MEMORANDUM

To: Simon Vuong, Assistant Planner, City of Cupertino

From: Franziska Church, Alexandra Sweet, and Jane Bierstedt, Fehr & Peers

Subject: *Focused Transportation Study for the Apple Cafeteria in Cupertino, California*

Figure 4 illustrates on-site circulation assessment for the underground parking garage. The assessments and recommendations are listed below.

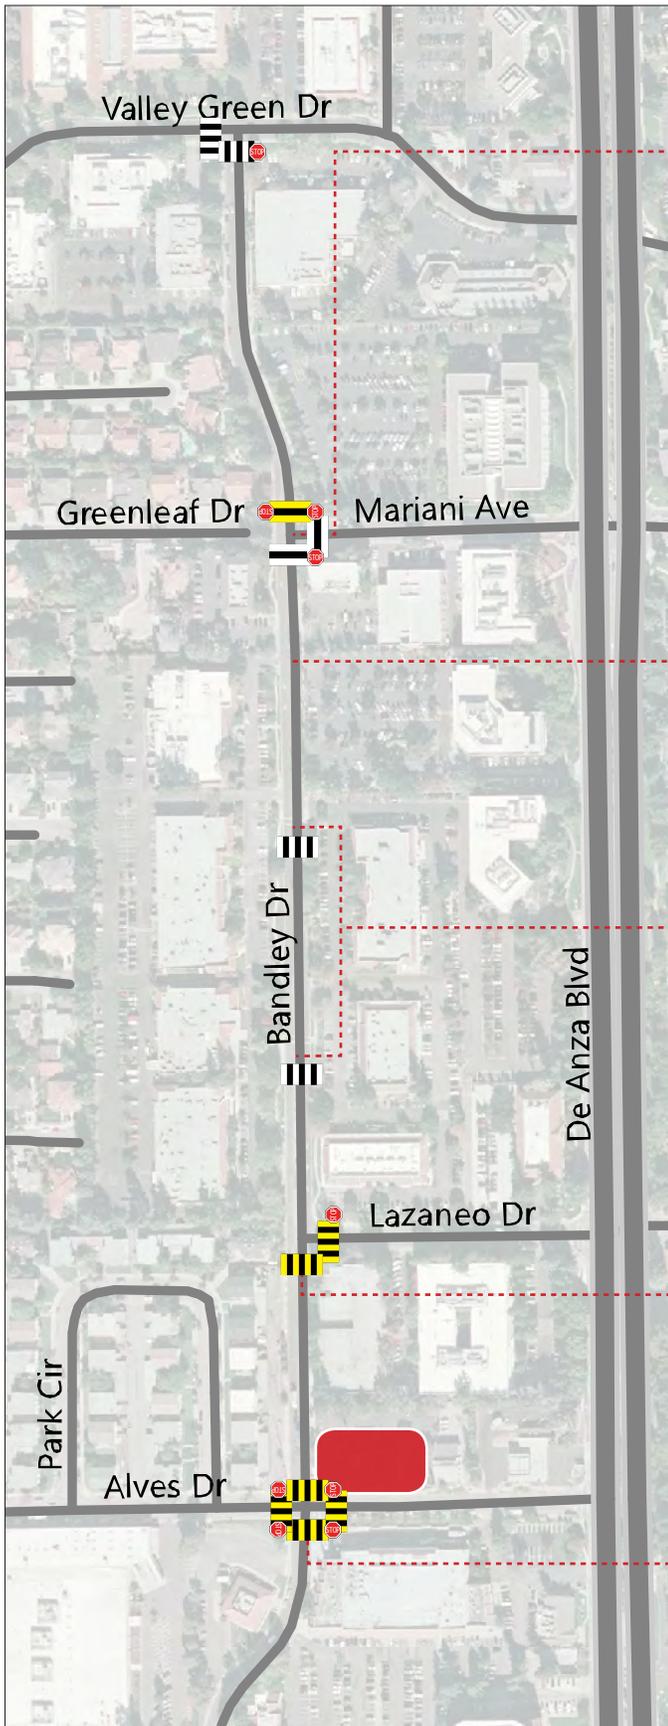
1. Add a stop bar and pavement legend to the intersection where circulating vehicles meet entering vehicles at the base of the ramp. The circulating vehicles should yield to the entering vehicles.
2. Add a stop sign, stop bar, left-turn arrow and "only" pavement legend at the base of the entrance ramp.
3. Extend the curb to the northern angled parking space and create a raised island adjacent to the exit ramp to protect it from exiting vehicles.
4. The 10'6" exit and entrance ramps may be too narrow. Consider widening the ramps by one foot, and provide a six (6) inch curb on one side and a one (1) foot curb on the other side. This design provides 10 feet of driving space and curbs, which provide a buffer between the vehicle and the concrete walls.
5. Push the northern row of parking against the garage wall to widen the circulation aisle.

The following section summarizes the multi-modal access analysis of the Bandley Drive corridor between Valley Green Drive and Alves Drive, including the four unsignalized intersections and two mid-block crosswalks. **Figure 3** illustrates site access opportunities and constraints.

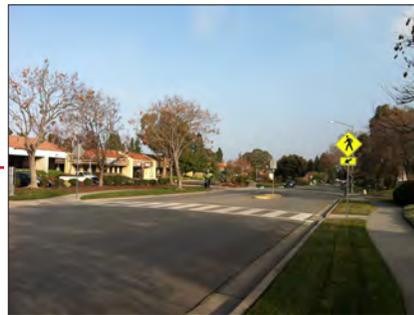
Bandley Dr./Mariani Ave.
This intersection does not have a striped northside crosswalk.

Bandley Dr./Lazaneo Dr.
Upgrading the southern and eastern crosswalks to high-visibility crosswalks will improve pedestrian safety.

Bandley Dr./Alves Dr.
This intersection does not have a striped northside crosswalk. All four legs should have high visibility striping treatment.

The assessments and recommendations for the street level circulation are illustrated on **Figure 5** and listed below.

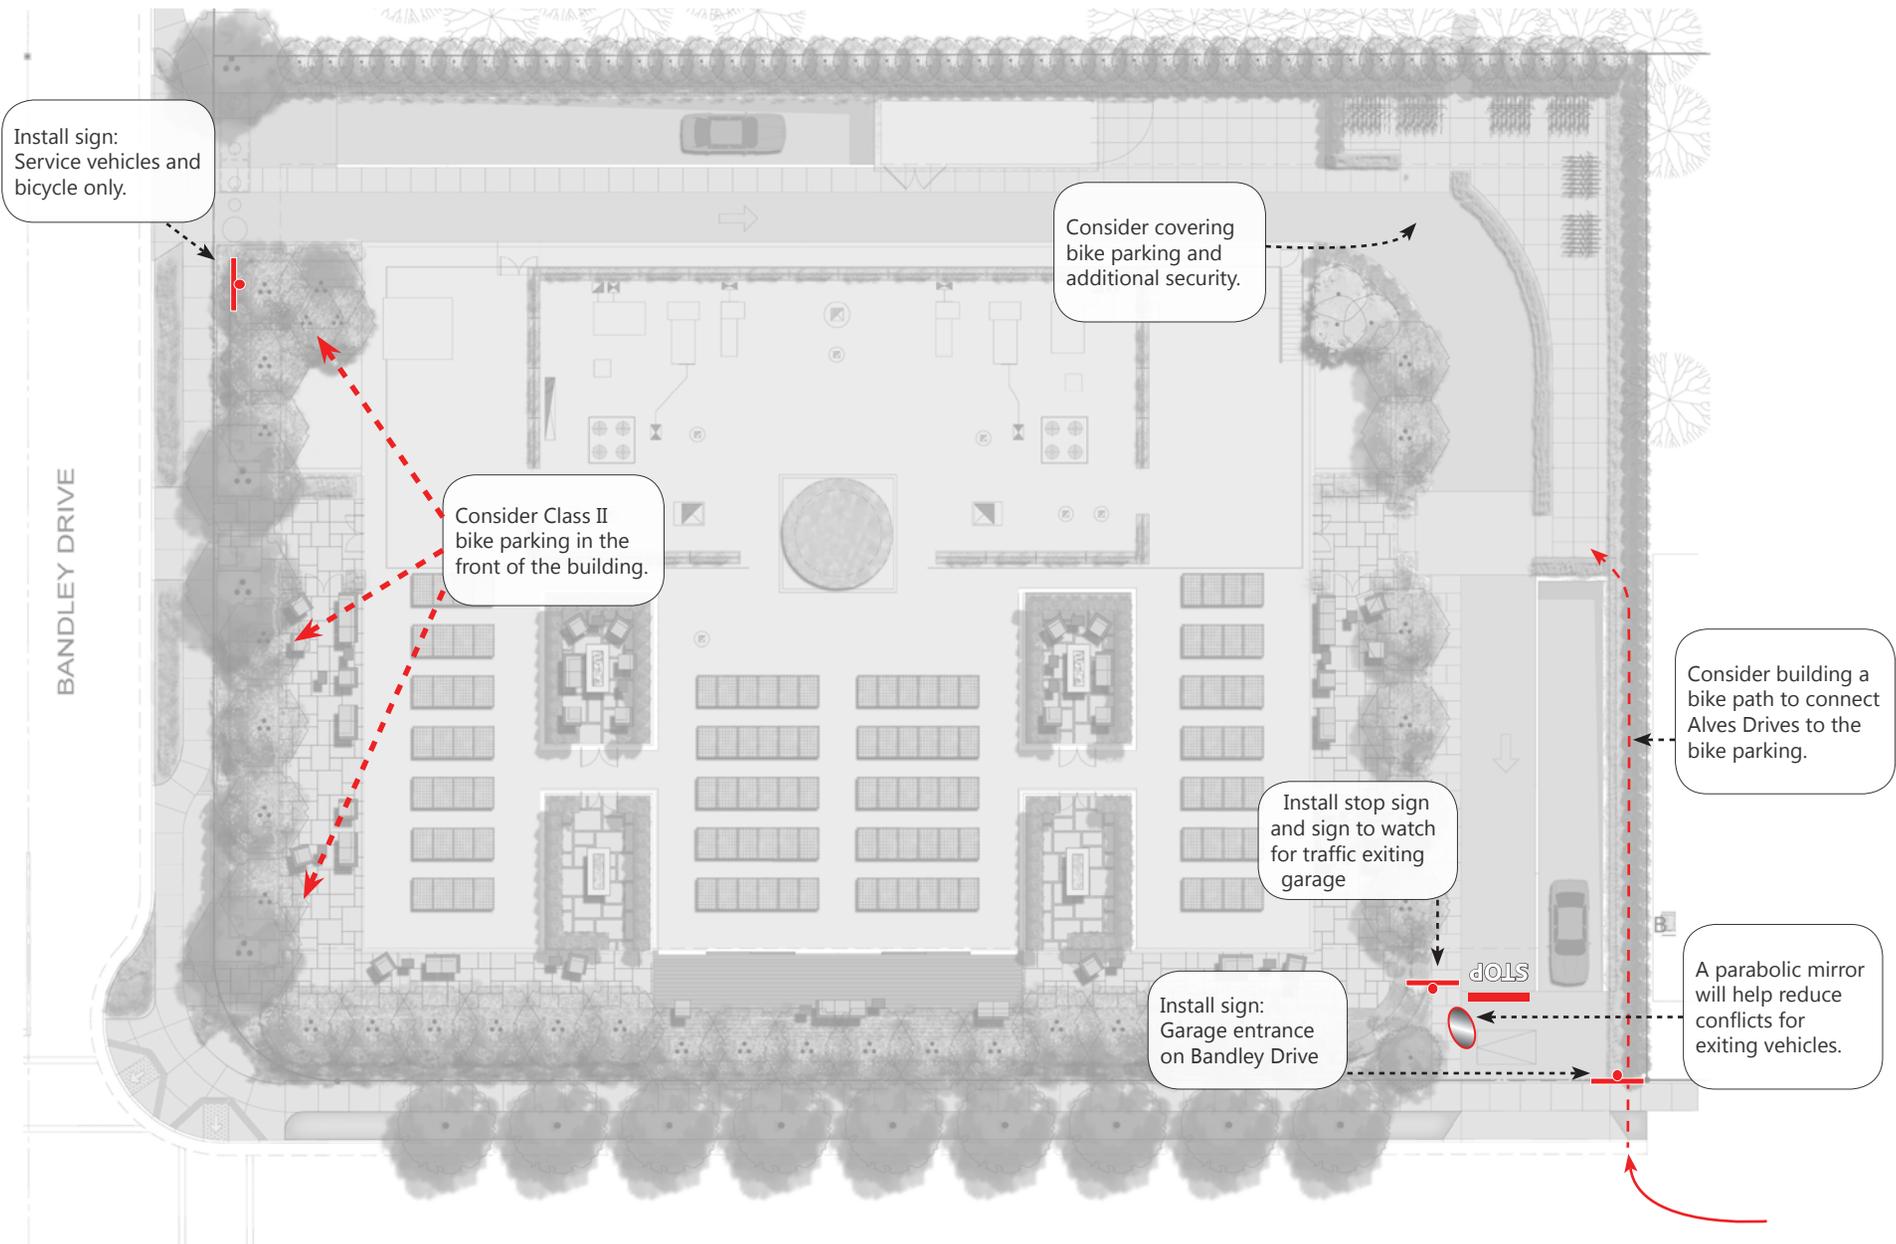
1. Post a sign at the service lane exit alert drivers of traffic exiting the garage.
2. Install a mirror adjacent to the service vehicle exit to improve visibility for drivers exiting the garage

3. Install a stop sign, STOP legend, and limit line where the service vehicle exit intersects the exit ramp.
4. Consider building a bike path along the eastern landscaped border to connect Alves Drive with the bike parking in the rear. As proposed, bicyclists may go the wrong-way down the one-way service driveway instead of biking around the block to access the bicycle parking in the rear of the building.

5. Install a sign at the garage exit that guides vehicles to the garage entrance on Bandlely Drive.
6. Consider adding a roof and additional security for the bicycle parking in the rear of the building. Hidden bike parking located a distance from the street may be more susceptible to theft. Secure and covered bicycle parking on the street level will be more attractive for long-term parking.

7. Consider adding short-term (Class II) bicycle parking near the building entrances on Bandlely Drive and Alves Drive.
